Well Name: SOTOL FEDERAL	Well Location: T24S / R31E / SEC 1 / SWNE /	County or Parish/State: EDDY / NM
Well Number: 7	Type of Well: OIL WELL	Allottee or Tribe Name:
Lease Number: NMNM69369	Unit or CA Name:	Unit or CA Number:
US Well Number: 3001528865	Well Status: Producing Oil Well	Operator: CHEVRON USA INCORPORATED

Notice of Intent

Type of Action: Plug and Abandonment

From: [Immatty, Keith P](#)
To: [Torres, Mark](#); [Stevens, Zota M](#)
Cc: [Savala, Jorge \[Airswift\]](#); [Wallace, Robert](#)
Subject: [**EXTERNAL**] RE: [EXTERNAL] Sotol Fed 7 - Updated Procedure
Date: Friday, April 14, 2023 5:40:32 PM

PROPOSED WELLBORE DIAGRAM

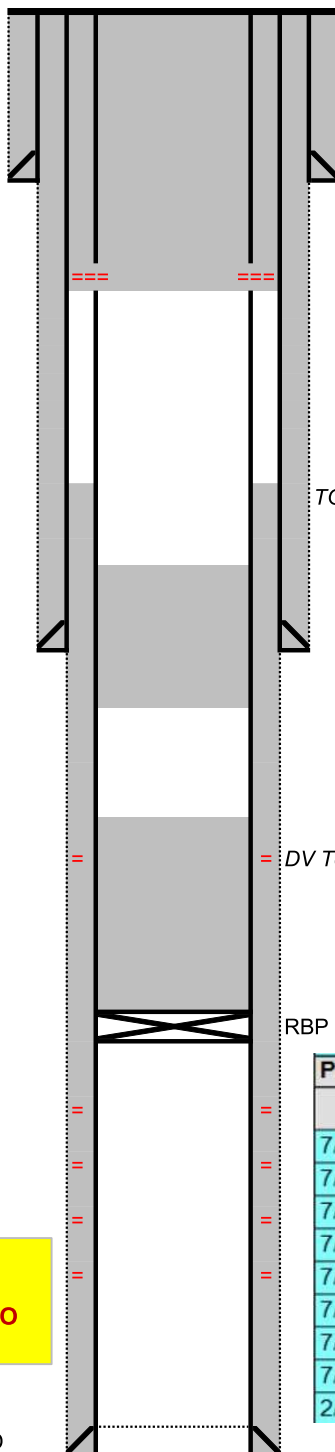
Isolate Salt top to surface per SOPA rules

Perf @ 1,500', circulate approx 371 sx Class C to surface

Isolate Delaware, Int. Csg Shoe, Salt Bottom

Spot 39 sx Class C f/ 4,545' - 4,169'

Tag and verify

Isolate Perfs, DV tool

Tag RBP, spot 60 sx Class C f/ 6,965' - 6,373'

WOC, tag, pressure test plug; min depth 6,423' (50' above DV tool)

500psi, 30mins

Sundry ID		2718521				
Plug Type	Top	Bottom	Length	Tag	Sacks	Notes
Surface Plug	0.00	1180.00	1180.00	Verify circulated to surface	371.00	Perf and sqz. Secretary potash. Bring top of salt plug to surface
Shoe Plug	365.80	470.00	104.20	Verify circulated to surface	371.00	Perf and sqz. Secretary potash. Bring top of salt plug to surface
Top of Salt @ 1130	1068.70	1180.00	111.30	Verify circulated to surface	371.00	Perf and sqz. Secretary potash. Bring top of salt plug to surface
TOC 3500'. Perf and sqz plugs above						
Base of Salt @ 4269	4176.31	4319.00	142.69	WOC and Tag	39.00	Covered by below plug
Shoe Plug	4365.40	4510.00	144.60	WOC and Tag	39.00	Covered by below plug
Delaware @ 4495	4400.05	4545.00	144.95	WOC and Tag	39.00	Covered by below plug
DV tool plug	6358.27	6523.00	164.73	WOC and Tag	60.00	Covered by below plug
CIBP Plug	6930.00	6965.00	35.00	WOC and Tag	60.00	Leak test 500psi, 30mins
